Proposed Code Modifications

This document created by the Florida Department of Business and Professional Regulation -
850-487-1824

TAC: Structural

**FIGURE R602.7.2
RIM BOARD HEADER CONSTRUCTION**

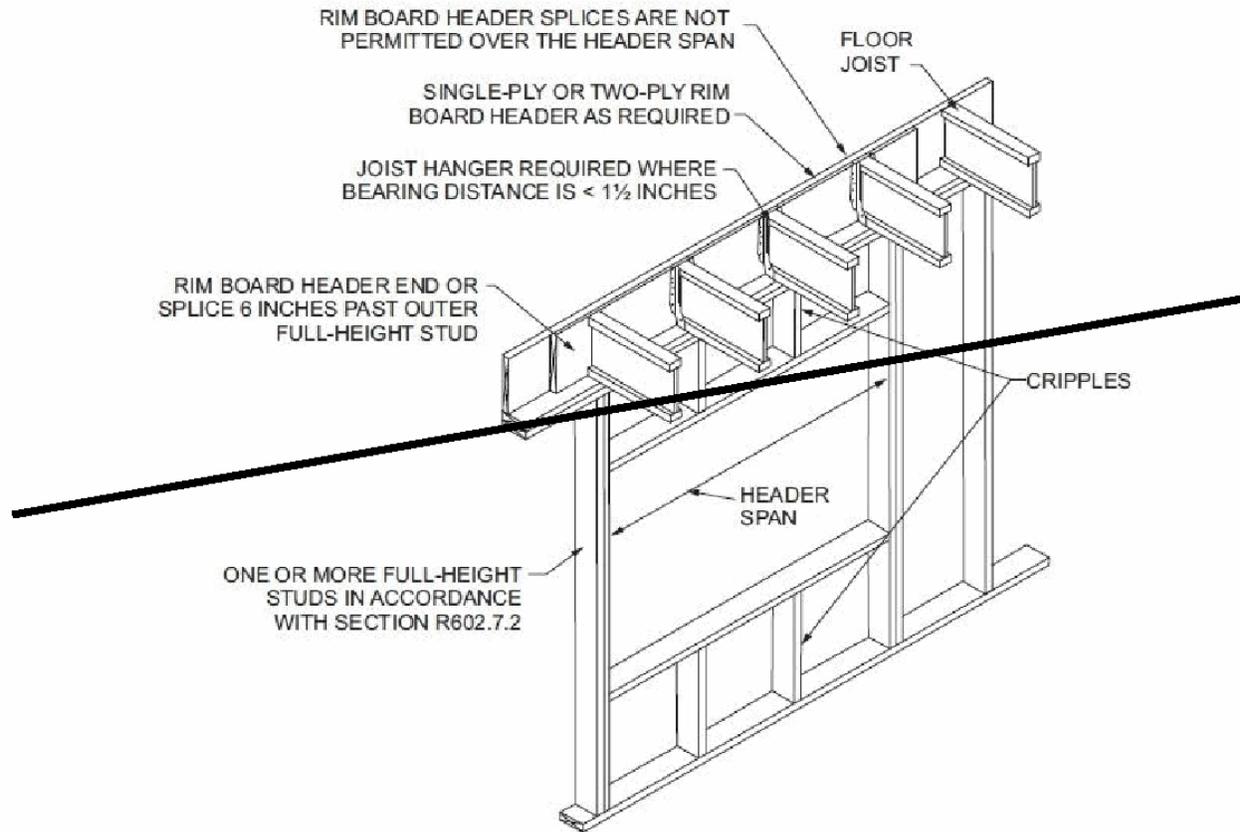
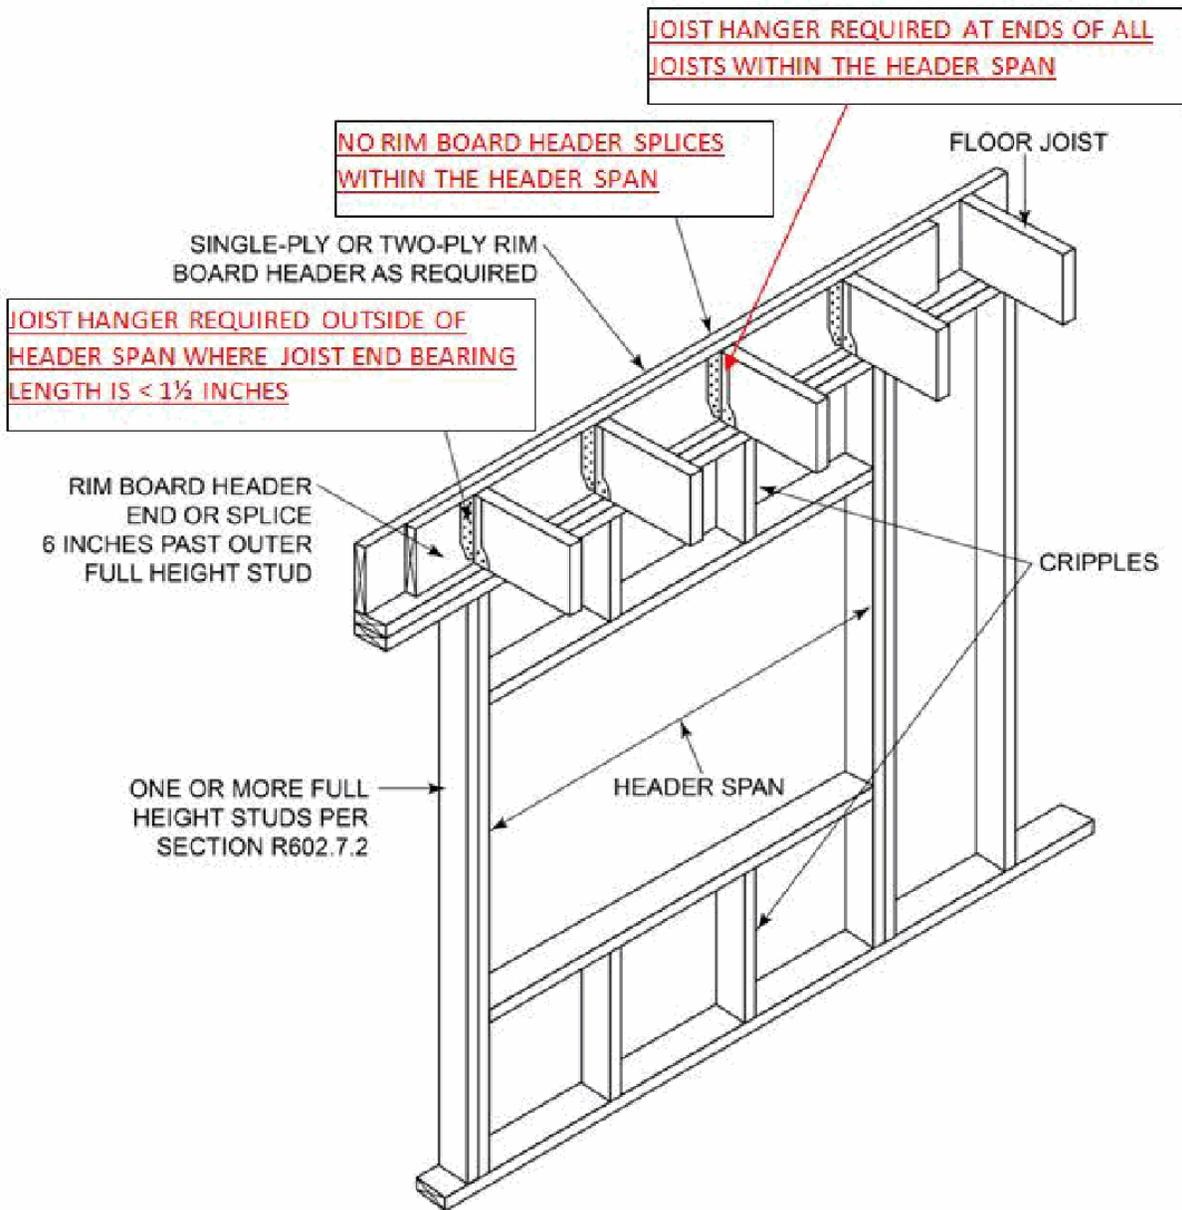
Revise as follows:
